APPEAL SUMMARY

Appeal ID: 19042	Project Address: 12121 E Burnside St
Hearing Date: 2/20/19	Appellant Name: Caroline Hather
Case No.: B-012	Appellant Phone: 5039521540
Appeal Type: Building	Plans Examiner/Inspector: Steven Mortensen
Project Type: commercial	Stories: 6 Occupancy: B,M,R-1,R-2 Construction Type: 1-A, III-A
Building/Business Name:	Fire Sprinklers: Yes - THROUGHOUT
Appeal Involves: Erection of a new structure	LUR or Permit Application No.: 17-174290-CO
Plan Submitted Option: pdf [File 1]	Proposed use: MIXED USE

Appeal item 1

Code Section OSSC 1020.1

EXHIBITS

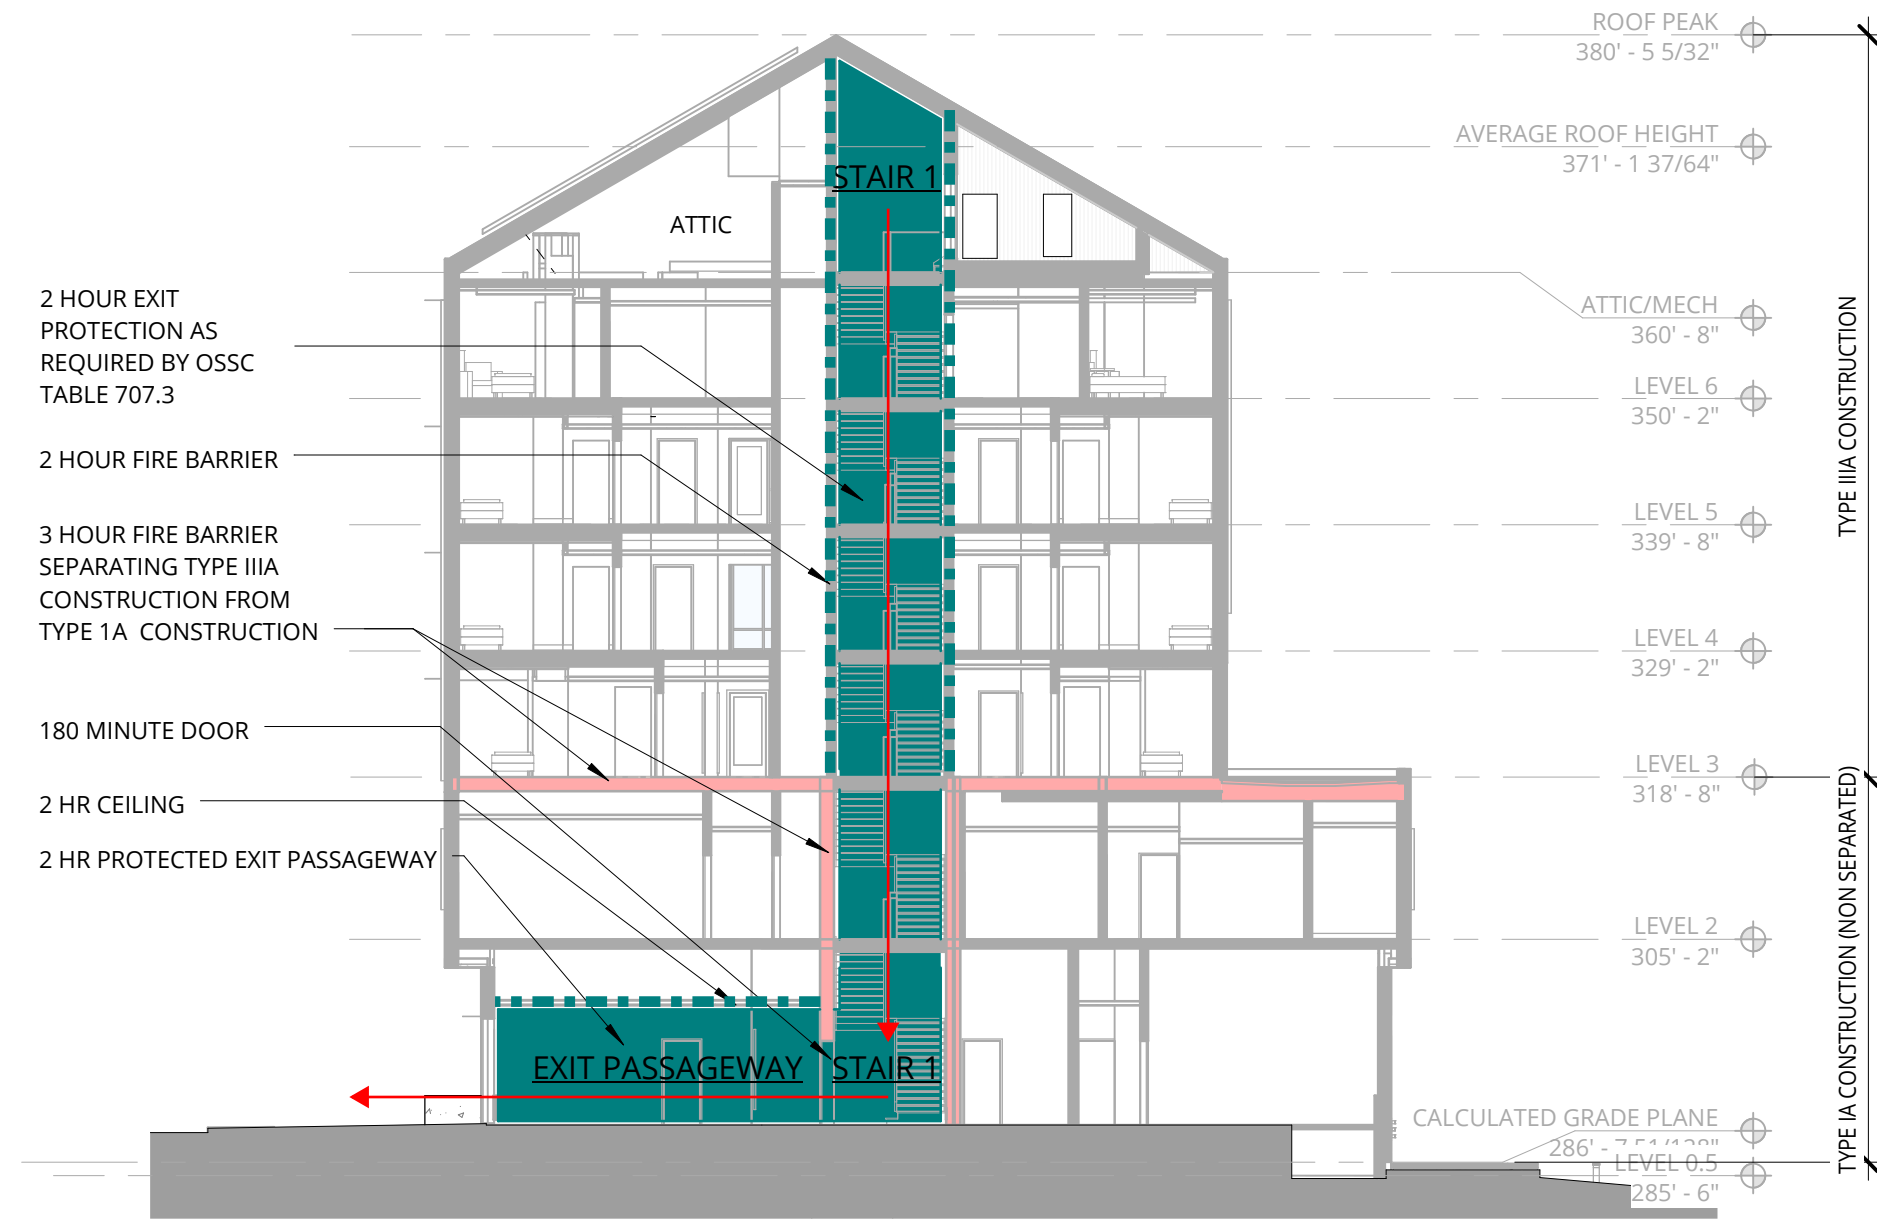
Proposed Design Exit passageway proposed to be protected by 2 hour fire barriers, 2 hour ceiling and a minimum of 90 minute doors per OSSC 1023.3. (See attached exhibits: proposed plan and section)

Reason for alternative Per 1023.3 The exit passageway Construction. Exit passageway enclosures shall have walls, floors and ceilings of not less than a 1-hour fire-resistance rating, and not less than that required for any connecting interior exit stairway or ramp. Exit passageways shall be constructed as fire barriers in accordance with Section 707 or horizontal assemblies constructed in accordance with Section 711, or both.

The required rating for the interior exit stairs and ramps for both the IA construction and the IIIA construction per 707.3 (1022.2) is 2HR. Therefore the exit passageway rating as 2HR is not reducing the required level of protection for the building occupants.

3 Hour protection has been provided at the stair solely for the purpose of continuing the IIIA construction down to grade level (as agreed at pre permit intake meeting 4/7/2017). The intent of the separation of building types is met without the continuation of the 3 HR protection through to the exit passageway construction since a fire within the stair would render stair 1 unusable. The exit passageway would be protected from this fire for 3 hours by way of the 3 hour stair enclosure and 180 minute door. This would ensure that the exit passageway could still be used for level 1 occupant egress and would not reduce the provided level of egress protection for those occupants from the required 2 hours for type IA construction per table 707. In this scenario, firefighters would use stair 2 for access.

Therefore we believe that reducing the rating requirement of the exit passageway to 2 hours provides the required fire life safety and meets the intent of the code.

Egress from 3 hour stair enclosure into 2 hour exit passageway: **Granted as proposed.**

The Administrative Appeal Board finds that the information submitted by the appellant demonstrates that the approved modifications or alternate methods are consistent with the intent of the code; do not lessen health, safety, accessibility, life, fire safety or structural requirements; and that special conditions unique to this project make strict application of those code sections impractical.

PROPOSED SECTION A

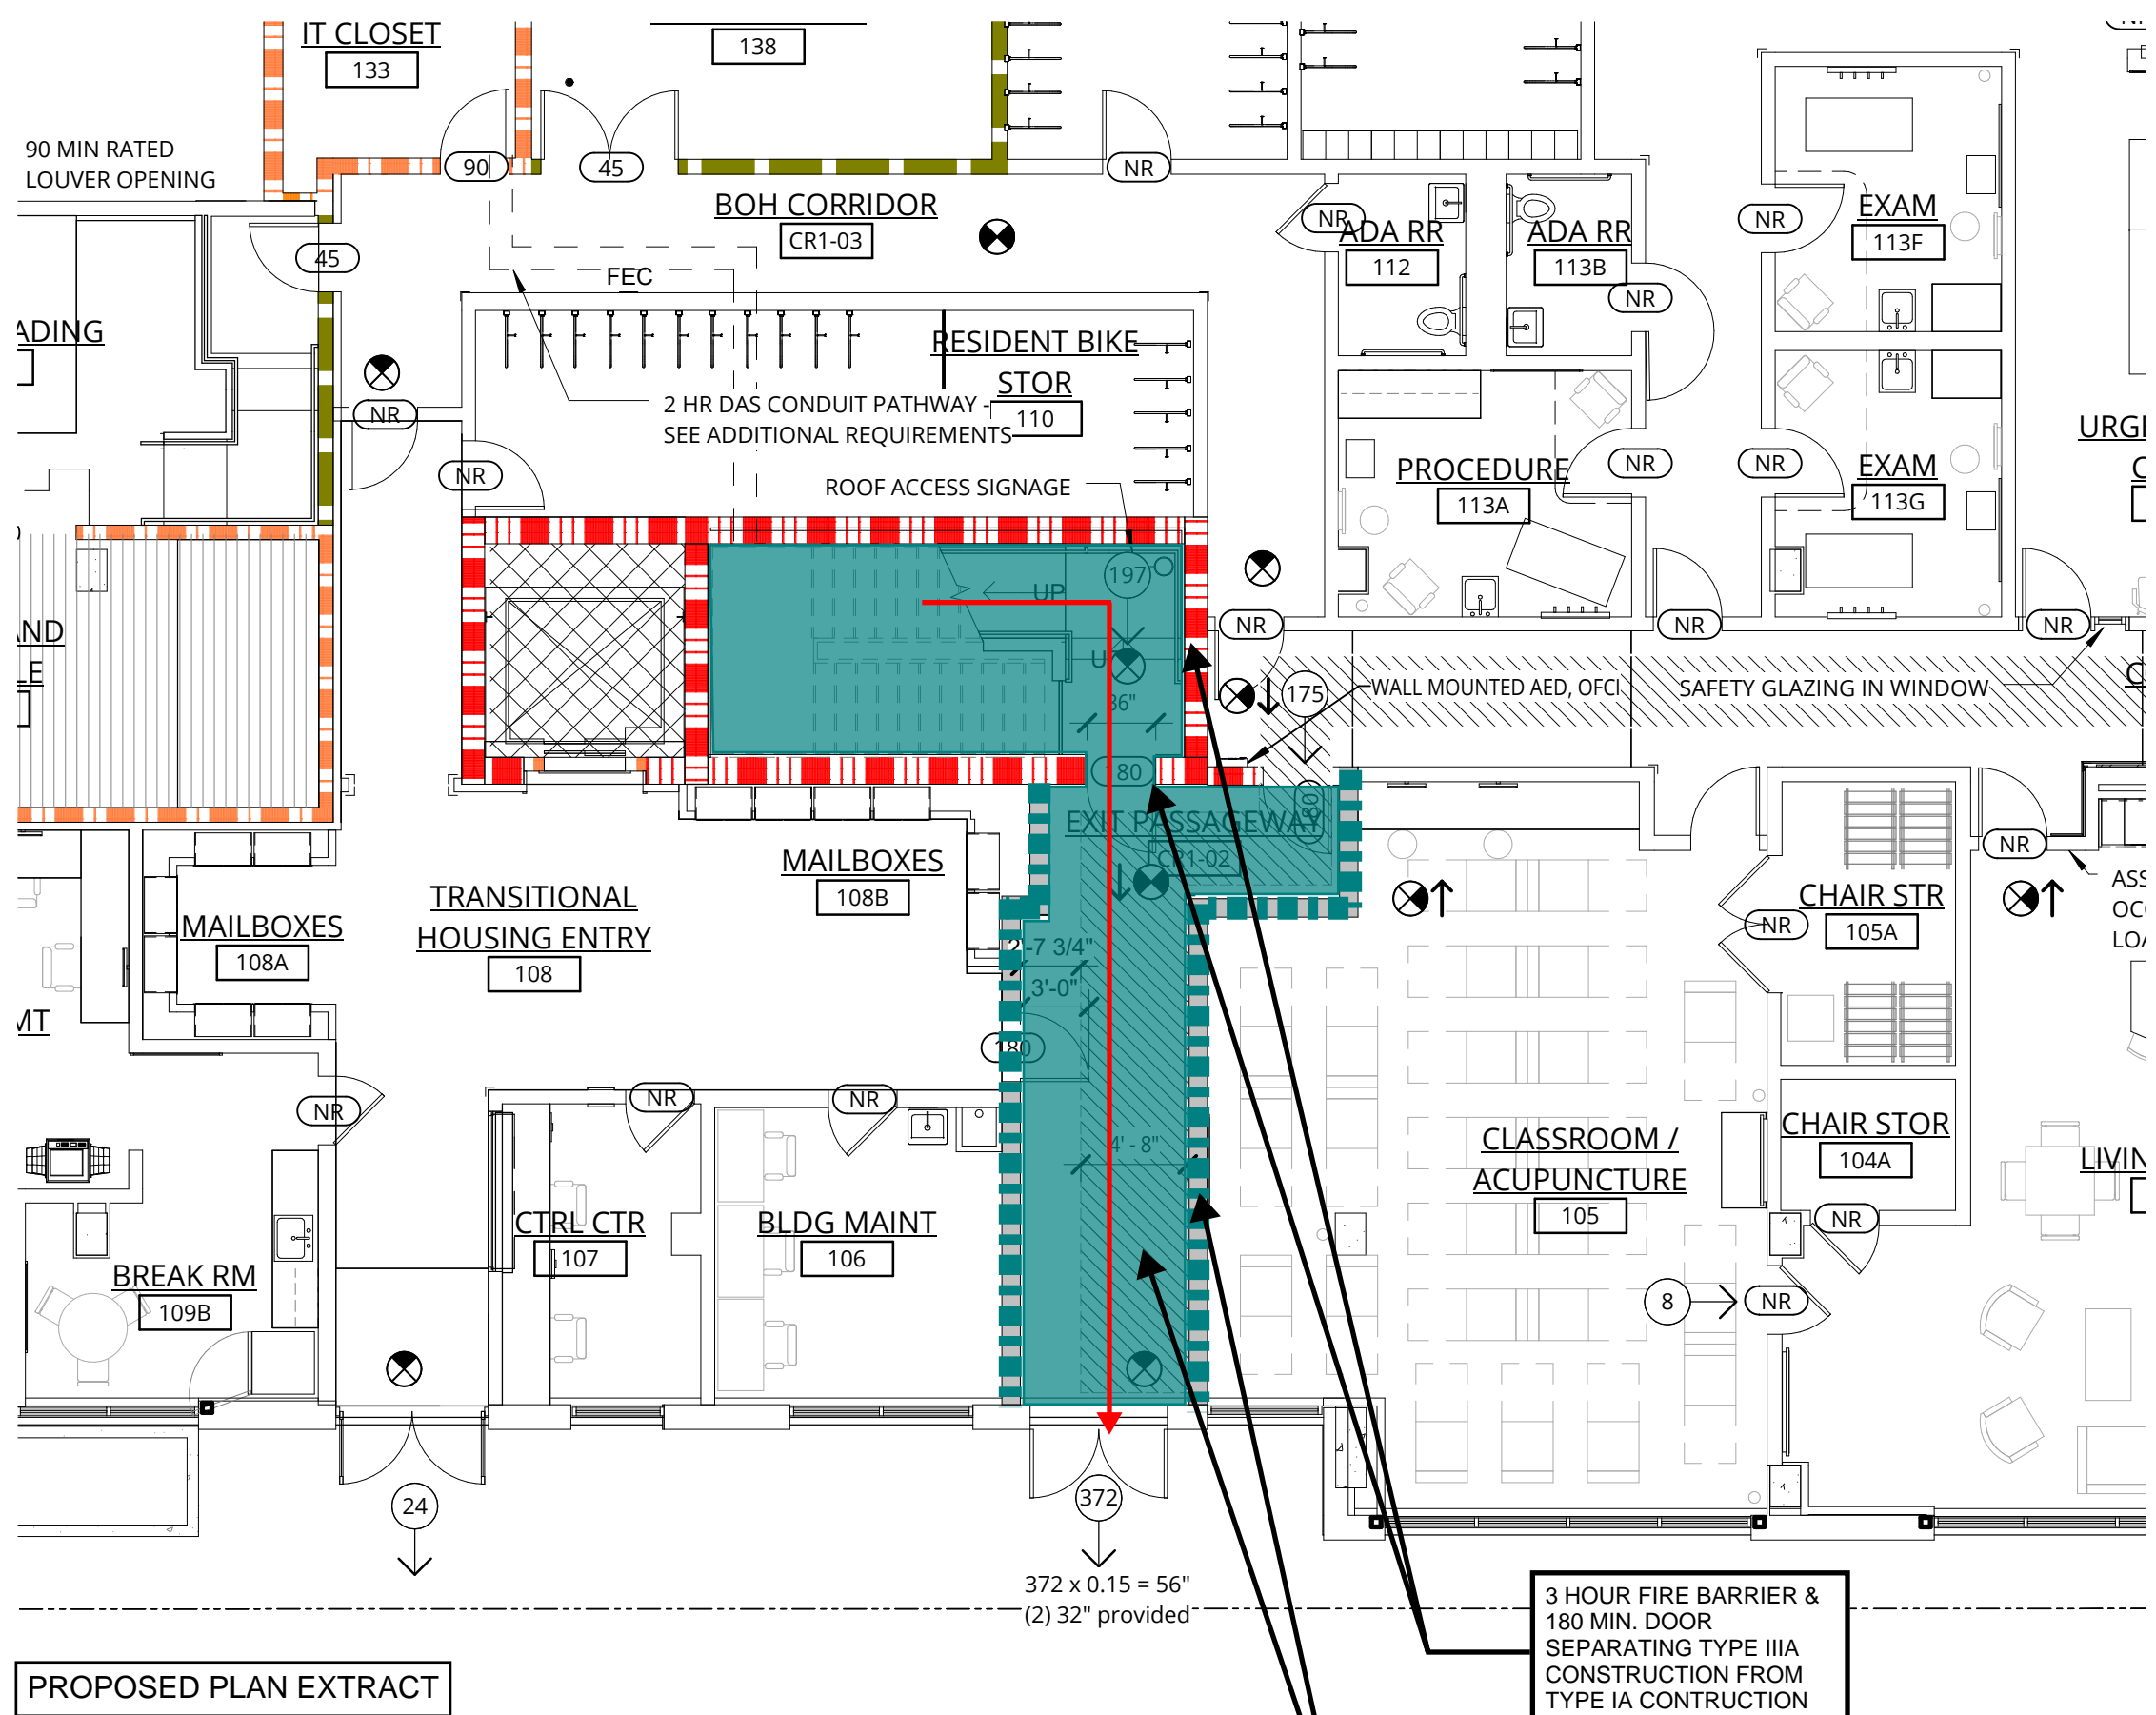
Exit passageway proposed to be protected by 2 hour fire barriers, 2 hour ceiling and a minimum of 90 minute doors per OSSC 1023.3. (See attached exhibits: proposed plan and section)

Per 1023.3 The exit passageway Construction. Exit passageway enclosures shall have walls, floors and ceilings of not less than a 1-hour fire-resistance rating, and not less than that required for any connecting interior exit stairway or ramp. Exit passageways shall be constructed as fire barriers in accordance with Section 707 or horizontal assemblies constructed in accordance with Section 711, or both.

The required rating for the interior exit stairs and ramps for both the IA construction and the IIIA construction per 707.3 (1022.2) is 2HR. Therefore the exit passageway rating as 2HR is not reducing the required level of protection for the building occupants.

3 Hour protection has been provided at the stair solely for the purpose of continuing the IIIA construction down to grade level (as agreed at pre permit intake meeting 4/7/2017). The intent of the separation of building types is met without the continuation of the 3 HR protection through to the exit passageway construction since a fire within the stair would render stair 1 unusable. The exit passageway would be protected from this fire for 3 hours by way of the 3 hour stair enclosure and 180 minute door. This would ensure that the exit passageway could still be used for level 1 occupant egress and would not reduce the provided level of egress protection for those occupants from the required 2 hours for type IA construction per table 707. In this scenario, firefighters would use stair 2 for access.

Therefore we believe that reducing the rating requirement of the exit passageway to 2 hours provides the required fire life safety and meets the intent of the code.
